**Seattle
Design
Commission**

**APPROVED
MINUTES OF THE MEETING
6 February 2003**

6 Feb 2003 Project: **Gasworks Park Site Plan**

6 Feb 2003 Project: **Northgate Library, Parks, and Community Center Site Plan**

Gasworks Park site plan context photograph.

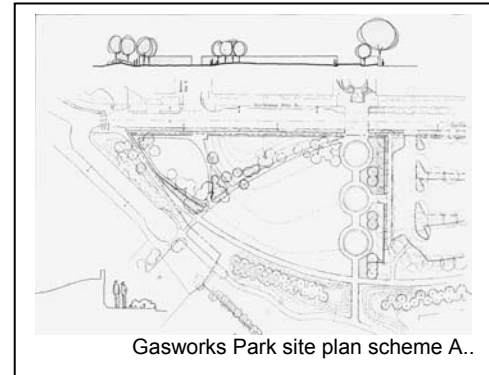
- recommends that the details be subservient to sweeping gestures and encourages the team to be bold in all design decisions such as in the way they breach the wall, deal with topography and the bioswale, recognize the tank forms as historical references, and deal with the issue of formality versus informality;

- Suggests that if the team breaches the wall, it should be done boldly; tell a story and cut sections so it draws attention. Is concerned about the view corridor because with the angle of the trees, passersby will not get this view from the streets at the east.

Gasworks Park site plan scheme A..

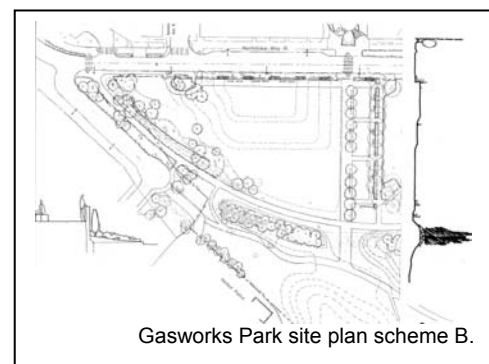
- appreciates the connection to Waterway 20 shown in scheme A and if scheme C is selected, encourages the connection to the waterway be brought into that design;

- Is not sure that there needs to be an axis, or one that is so literal. Feels that there could be a visual axis, but circulation could be different. Likes the connection with the waterway in scheme A and feels

Gasworks Park site plan scheme C.

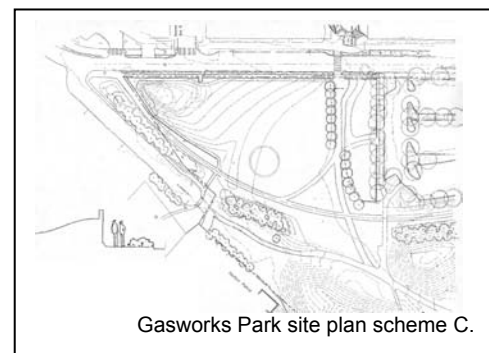
- suggests that schemes A and C are most appropriate, and scheme C has strong characteristics in terms of scale, topography, and geometry; and
- recommends approval of early concept design and looks forward to seeing the preferred concept.

- Agrees that the team should be bold in their treatment of the wall and park. Feels that scheme C is the closest to the original conception of the park as a series of large landforms. Feels that B is the weakest with the sidewalk inside and outside the wall, flattened landforms, lack of clarity. Would like to see cleanly delineated edges and simple, bold design.

that C could use that aspect. Suggests that instead of Prow Hill in scheme C, there could be grand stairs. In the principles, the team talks about importance of scale and no exclusivity of uses and feels that the dog run presents a problem with regard to these. Believes the team is on the right track with the vegetation and it should be big and bold. Suggests that the bioswale concept be taken used to make a large, sweeping gesture. Feels that the parking should be put on the other side so people can sit in their cars and look out onto the water even on rainy days. Urges the team to make sure the details are subservient to the big, sweeping concept.

- Is uncertain about the suggestion for stairs where people enter at Prow Hill and feels it looks constricted.
- Believes that you could take away the corner and back the hill with large sweeping steps.

- Agrees, but feels that the prow seems unnecessarily pinched.
- Disagrees and feels that that corner should not be whittled away at.
- Believes that he might reject formality if in a place like New York or somewhere where the naturalness is hard to find. However, here there is informality everywhere and feels that for a city that wants to be more urbane, formality should not be rejected. Also feels that there needs to be more of a balance of the city's needs *vis-à-vis* the neighborhood and that this park is region-wide treasure. Believes the big sweeping gestures need to be looked at from a broader perspective of the region.

Northgate site linked building schemes.

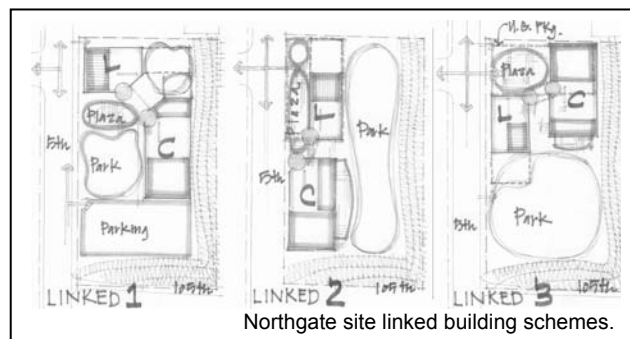
- Agrees that the team should use the existing signal as the entry.
- Agrees that the blight of this neighborhood is surface parking and urges the team to think of the scale and ways to finesse the buildings together to pay for underground parking. Would like the buildings to be a bigger scale to compete with the overwhelming commercial blight. Feels that with 5th Ave. NE being planned as a more pedestrian street, surface parking is a problem. Also feels that park with a relatively small presence toward the street and privacy is a good idea.

Northgate site attached building schemes.

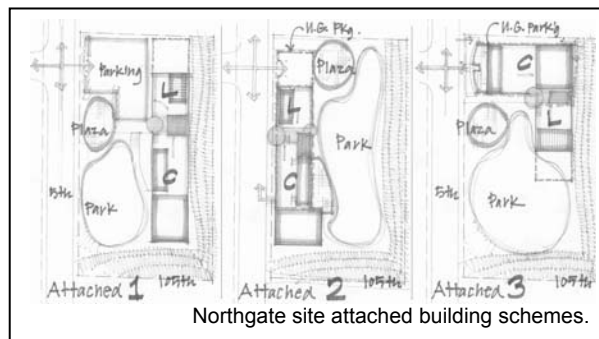
- Supports the team putting as much building edge mass along 5th Ave. NE. Feels that 2/3 of the building edge could be along the street with just a part of the park. This puts park in the larger context of Thornton Creek. Urges the team to everything they can to get underground parking.

Northgate site separate building

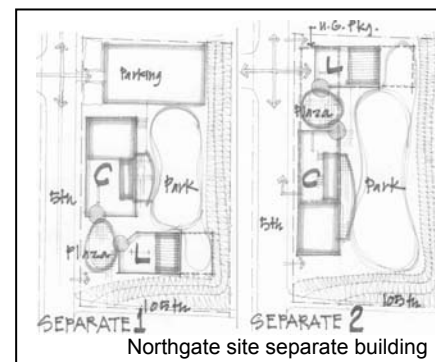
- Feels that the park uses need to be delineated more clearly. Assuming the steep banks are not changed, encourages the team to look at terracing and how the park might terrace down and give access to Thornton Creek. The terracing could be used for different activities.

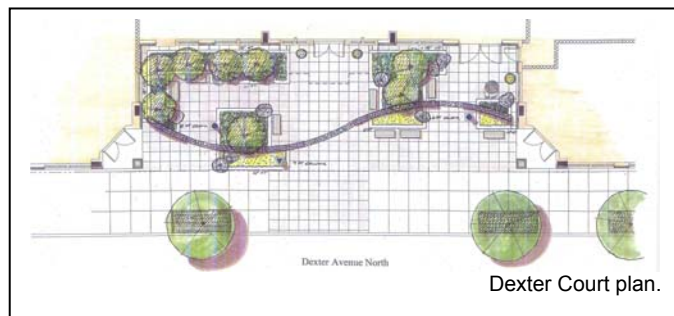
- Would like to know more about the exterior lighting.
 - Proponents stated that they haven't approached the whole scheme yet.
- Would like to know if there is a way to use lighting in and on the columns as plaza lighting system.

- Sees that in the former drawings the plaza has movable seating and in the newest version there are just benches.
 - Proponents stated that they will have movable furniture in the plaza.

- Supports the idea of getting a deviation from SDOT for the paving pattern.
- Would like to know why the glass is not carried through from the main canopy to the storefront awnings.

- Proponents stated they are not sure that is enough light. The columns are reflective inside so that might help and the artist may put a patina on them. The light in the columns is primarily to make the cutouts snap.

- Proponents stated that it is a matter of cost and maintenance. It takes a lot of maintenance to keep the glass clean.
- Would like to know if this solution is satisfactory for DCLU.
